Subject: RUBBER PROTECTOR PARTIALLY COMES OFF SIDE STEP MOLDING CAUSING A POOR APPEARANCE CONCERN	Bulletin No: 09-031/14
	Last Issued: 07/11/2014

APPLICABLE MODEL(S)/VINS

2013 CX-5 vehicles with VINs lower than JM3KE*****162631 (produced before November 1, 2012)

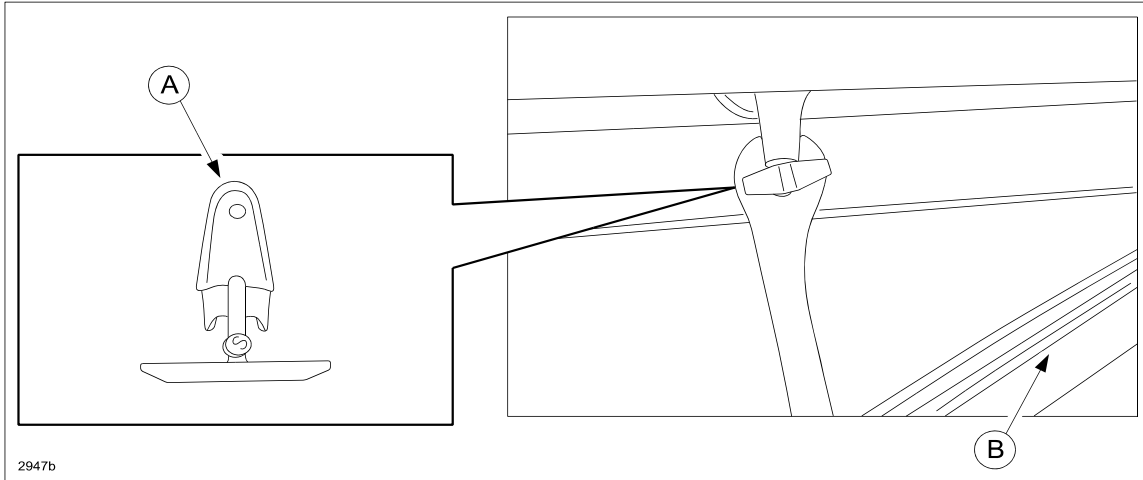
Some customers may complain that the rubber protector comes off the side step molding. The protector hangs down causing a poor appearance concern.

This concern may occur when the vehicle is driven in freezing temperatures. Snow and moisture adhere and freeze onto the rubber protector and when the door is opened, the rubber protector can tear or stretch, coming off the fasteners.

The material of the rubber protector around the fasteners has been changed to increase the holding force to the fasteners.

1. Verify customer concern.
2. Remove the twelve (12) fasteners (A) and rubber protector (B) using a fastener remover.

3. Install a new rubber protector.
4. Repeat the repair on the opposite side of vehicle as necessary.
5. Verify repair.
